Product Change – Wieland Earth Terminals of the *selos* WK range.

November 2015

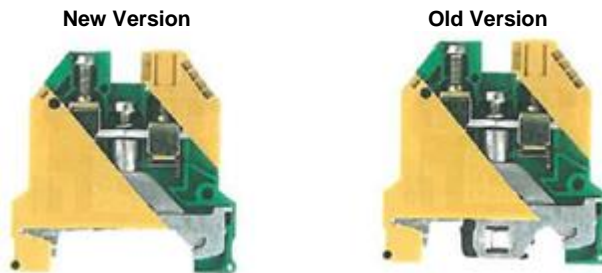
The part numbers below have, in the past, had a Universal mounting foot so that they would fit on to TS35 top hat rail and also TS32 G rail. This **mounting foot design will now change** and these parts will, in the future, only fit TS35 top hat rail.

This change was prompted by the declining use of G rail and will **simplify the fitting** of the terminals on to TS35 rail.

The change will not affect the technical data or approvals of the product for use on TS35 din rail.

If earth terminals are required for TS32 G rail, then these will be available under the part numbers in the format 54.5xx.9x55.0.
